MEMORANDUM

Re: **RPM Development, LLC**
Amended Preliminary and Final Major Site Plan and Subdivision
Orchard Road and Community Drive
Block 20001, Lot 10.05
Municipal Center Redevelopment Zone (MCRZ)

Date: February 27, 2023

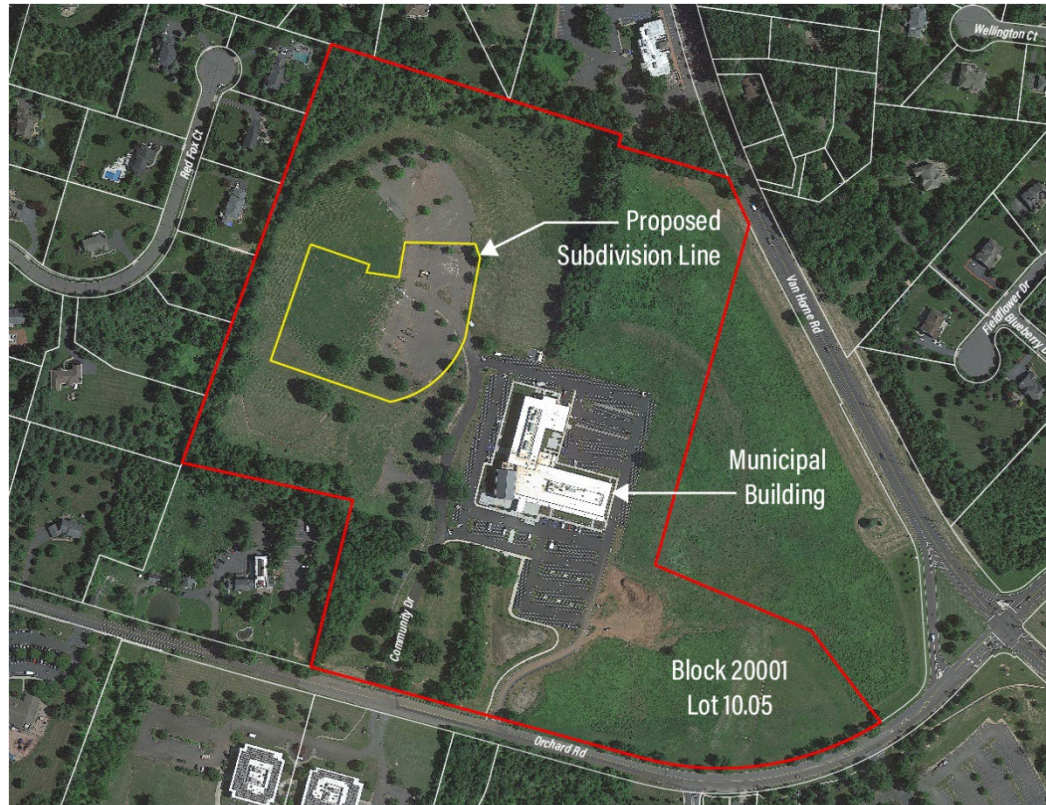
Amended Preliminary Approval Required: Amended preliminary approval is required for this application because a variance from N.J.S.A. §40:55D-35 is required to permit construction on a lot (proposed lot 10.07) that does not have frontage on a public street.

- 1.2 **Variance Relating to Public Street Access:** Pursuant to N.J.S.A. §40:55D-35, permits for the erection of any building or structure shall not be granted if a lot does not front on a public or private street. The proposed Lot 10.07 does not abut a street. This variance is from the Statute, rather than from the local Land Development Ordinance. The Planning Board has the power to grant this variance pursuant to N.J.S.A. §40:55D-76a(2).

- 1.3 **Changes from Original Preliminary Site Plan Approval:** There are some changes from the plan approved in July of 2021 to the current plan. The most significant change is the proposal of a grass paver emergency access road, which connects to a basin access road. A portion of the emergency access road is proposed to be located on Lot 10.05, as is the majority of the basin access road. The proposed crushed gravel trail has been redirected such that it connects to the paver patio and no longer extends further north into Lot 10.05. Existing curbing that was damaged is proposed to be replaced and new curb ramps are proposed. The proposed changes do not result in any changes to impervious or building coverage. The number of proposed and types of lighting has increased.

Portion of Existing Parking Area to be Repurposed for Proposed Development

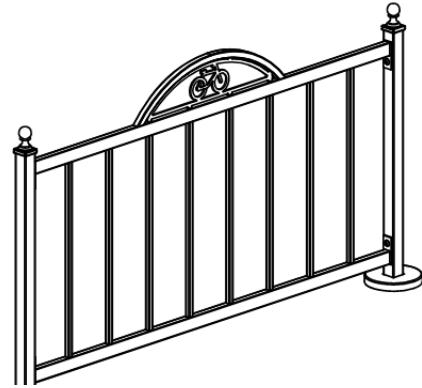
- 5.1 **Off-street Parking Requirement:** Pursuant to §16-4.16G.1, off-street parking shall be provided pursuant to the NJ RSIS. The type of development proposed would fall under “midrise” or “garden” style apartments, both of which contain the same parking standards under RSIS. The requirement is 1.8 spaces per one-bedroom unit and 2 spaces per two-bedroom unit. The applicant is proposing 129 spaces. The following table indicates the required number of spaces per RSIS, which is 128. The plan complies.

The plan indicates that future spaces may be proposed in a second phase of development, however, these are not accounted for in the current proposal.
